AGENDA
Planning Commission Regular Meeting
Tuesday, September 23, 2025
6:30 PM
City Council Chambers, City Hall

AGENDA ITEM: Request by Aspen Fields, LLC., for a Site Plan Review to develop a childcare facility.	AGENDA SECTION: PUBLIC HEARINGS
PREPARED BY: Julia Hogan, Planner	AGENDA NO. 6.a.
ATTACHMENTS: Site Location, Existing Conditions, Erosion Control Plans, Civil Site Plan, Vehicle Turning Radius Exhibit, Grading Plan, Utility Plan, Landscape Plan, Architectural Renderings, Photometric Plan, Engineer's Memorandum Dated September 16, 2025, Parks and Recreation Review Memo dated June 16, 2025	APPROVED BY: AK
RECOMMENDED ACTION: Motion to approve a site plan review allowing Aspen Fields, LLC, to construct a childcare facility, subject to the following conditions: <ul style="list-style-type: none"> a. Conformance with all requirements of the City Engineer as detailed in the attached memorandum dated September 16, 2025. b. Payment of \$21,510 in lieu of park land dedication prior to the issuance of a building permit. c. Payment of any remaining development fees not collected during the plat process. d. The applicant shall apply for and receive a sign permit prior to the installat

**EXISTING CONDITIONS AND SITE PREPARATION**  
POLLUTION PREVENTION PLAN

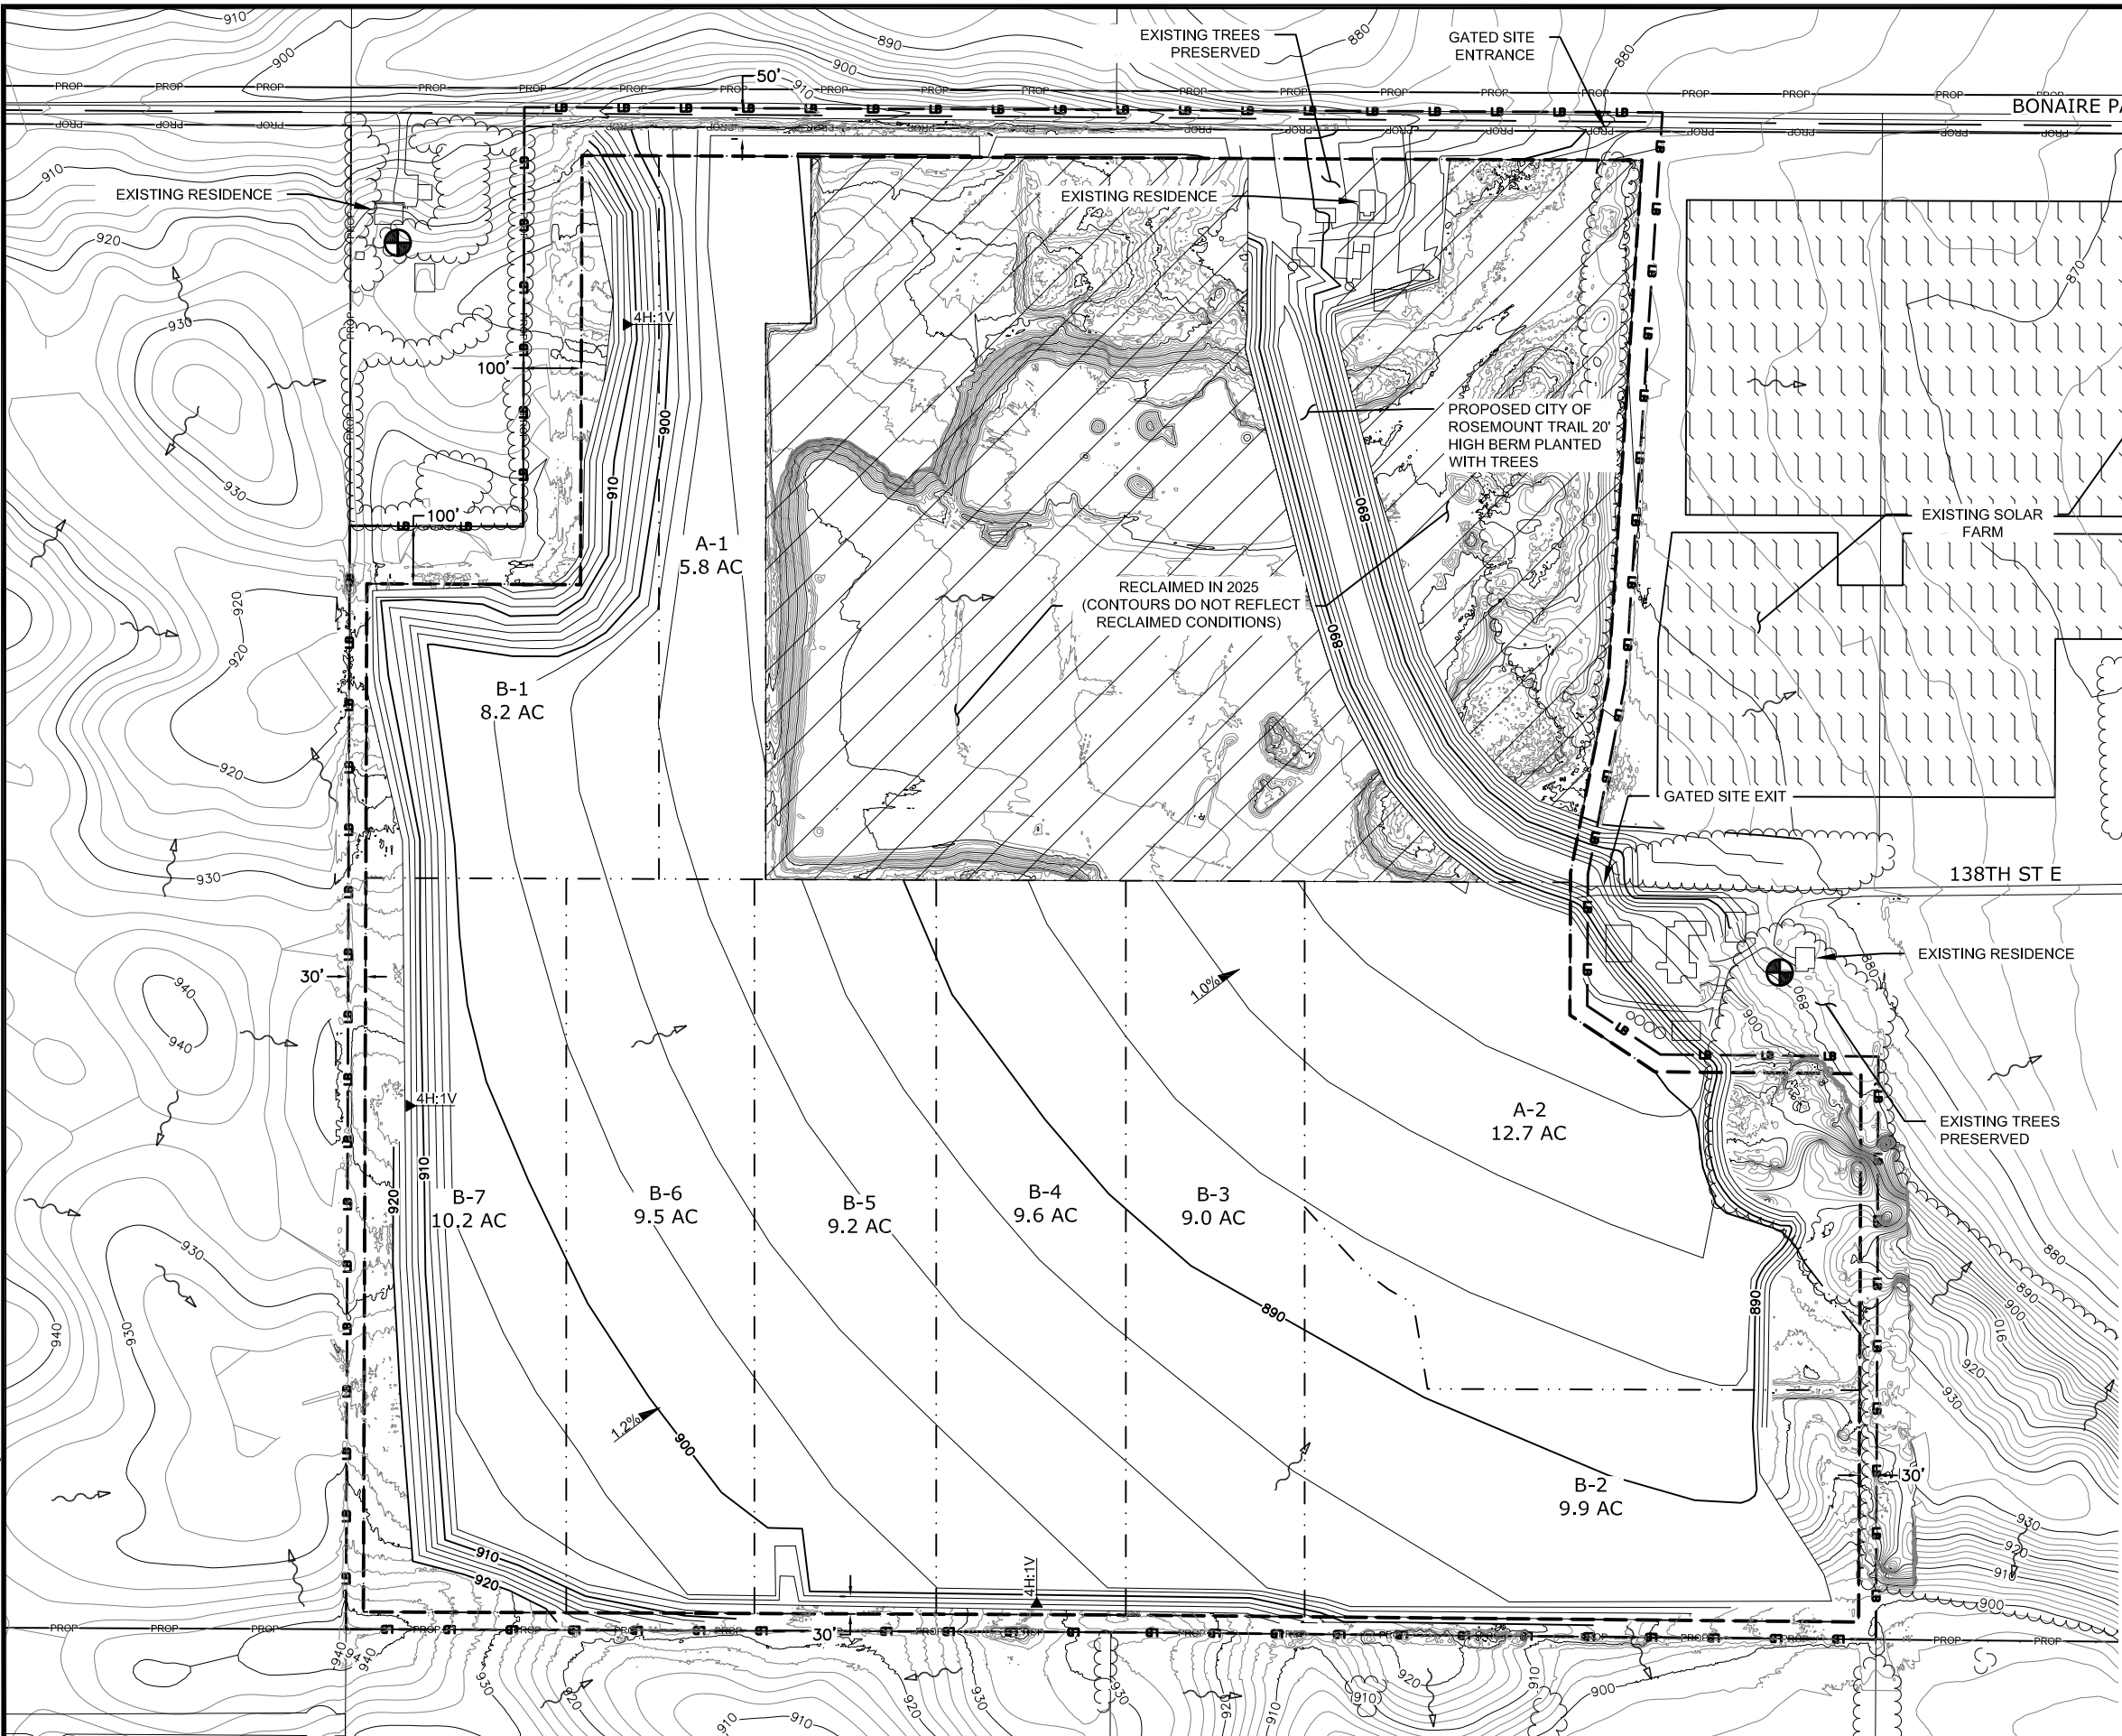
- B. This permit is granted for the area designated as ~~Solberg Phase 1, Bolander Phases 1 and 2, and Frattalone Phase 1A-1 and A-2 and B-1 and B-2 on Exhibit 1 Present Conditions and 2025 Mine Plan~~ the plan titled Existing Conditions and Site Preparation.

- I. No topsoil shall be removed from the site and the Property Lessee shall take necessary measures to prevent erosion of the stockpiled topsoil. The location of the stockpiled topsoil is ~~located on Present Conditions and 2025 Mine Plan~~indicated on the Existing Conditions and Site Preparation plan as diversion and screening berms.
